Service Bulletin

Bulletin No.: 16-NA-111

Subject: Information on Malfunction Indicator Light (MIL) Illuminated, DTC P0420 and P0430 Set

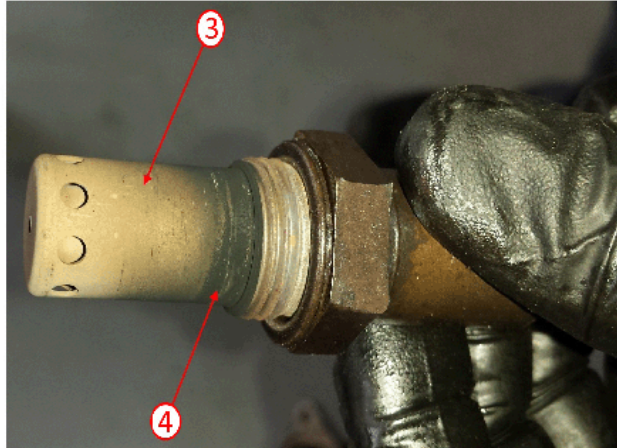
1. Inspect the air housing cover for any missing tabs and/or fasteners (1).
2. Remove the air filter housing cover and inspect the seal around the air filter (2).

3. Inspect the air filter sealing surface for signs of not contacting the air filter seal (1, 2).

4. Inspect the air filter housing cover for dirt and/or debris bypassing the air filter (3).
5. Inspect the air cleaner outlet duct for any dirt and/or debris.
 - If dirt and debris has been found bypassing the air filter due to a faulty seal, replace the air filter as necessary.
 - If the air filter housing has been found not properly sealing, refer to *Air Cleaner Assembly Replacement* in SI.

4487580

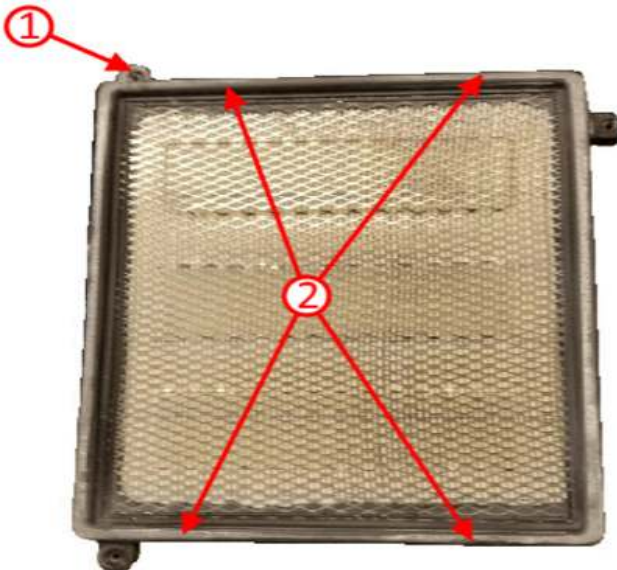
This may be caused by excessive sand and/or debris entering the air filter box and bypassing the seal of the air filter due to not properly sealing, causing damage to the HO2 sensor element (3) and the catalytic converter to become blocked with sand and debris particles (1, 2).

Do not replace any of the parts until the air filter housing has been validated to be completely sealed. If the condition is evident, inspection of the air box and air filter seal must be done. Follow the Service Procedure steps in order to verify the sealing of the air filter to housing surface. After validating the air box has been sealed, repair the P0420 and the P0430 codes **as needed**.
